Access Compliance Report

Public Rights-of-Way

Intersection ID: 47103	Main Street: POLK_AND_WHITE_RD	Cross Street: HATTIE_LITTLE_ST	Location: NW
ADA ID: 98BFF7EE28E4	Ramp Type: BlendTrans1	Initial Pass/Fail: Fail	Overall Compliance: No
		Severity Score: 10

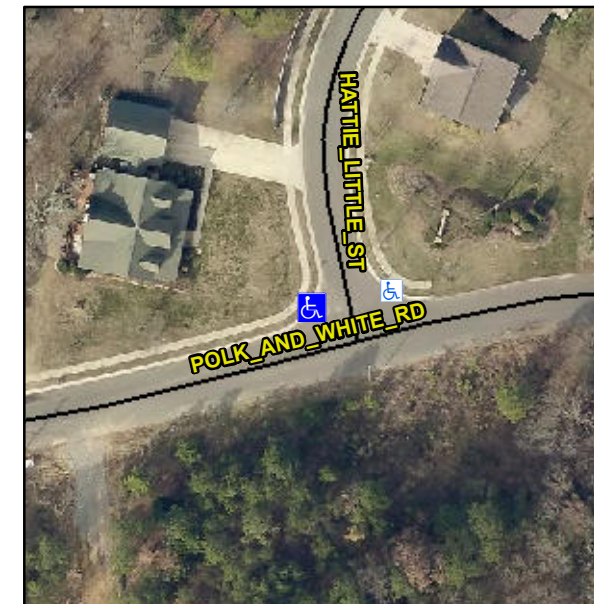
Not Found, R304.5.1, R304.5.3

Compliance	Description	Data	Compliance	Description	Data
N/A	Ramp Length (in)	46.0	Yes	BlendTrans Slope (%)	1.5
No	Ramp Width (in)	45.0	No	BlendTrans XSlope (%)	2.2
N/A	Flare Type LT	N/A	N/A	Flare Type RT	N/A
N/A	Flare Slope LT (%)	N/A	N/A	Flare Slope RT (%)	N/A
N/A	Flare Traversable LT?	N/A	N/A	Flare Traversable RT?	N/A
N/A	Landing Length (in)	N/A	N/A	DWS Provided?	N/A
N/A	Landing Width (in)	N/A	N/A	DWS Contrast?	N/A
N/A	Landing Slope (%)	N/A	N/A	DWS Length (in)	N/A
N/A	Landing X Slope (%)	N/A	N/A	DWS Full Width?	N/A
N/A	Landing Curb? (Y/N)	N/A	N/A	DWS Offset (in)	N/A
N/A	Shared Landing?	N/A			
N/A	Gutter Ponding?	N/A	N/A	Gutter Slope (%)	N/A
N/A	Gutter Lip Ht (in)	N/A	N/A	Gutter X Slope (%)	N/A
N/A	Painted X Walk1?	No	N/A	Painted X Walk2?	N/A
	X Walk 1 Direction	To E		X Walk 2 Direction	N/A
	X Walk 1 Width (in)	N/A		X Walk 2 Width (in)	N/A
	X Walk 1 Slope (%)	0.2		X Walk 2 Slope (%)	N/A
	X Walk 1 X Slope (%)	0.8		X Walk 2 X Slope (%)	N/A

N/A	Ramp inside XWalk1?	N/A	N/A	Ramp inside XWalk2?	N/A
	Road Slope (%)	0.8		Clear Space?	N/A
	Road X Slope (%)	0.2	N/A	Clear Space to XWalk (in)	N/A
N/A	Any Obstructions?	N/A	N/A	Storm Grate/Utility Hazard?	N/A
	Obstruction Type			Storm Grate/Utility Type	
		N/A			N/A
			Yes	Surface Condition? (G/P)	Good
			No	Curb Slope (%)	5.5

Remove & Replace Curb Ramp With Two New Directional Ramps or Equivalent.
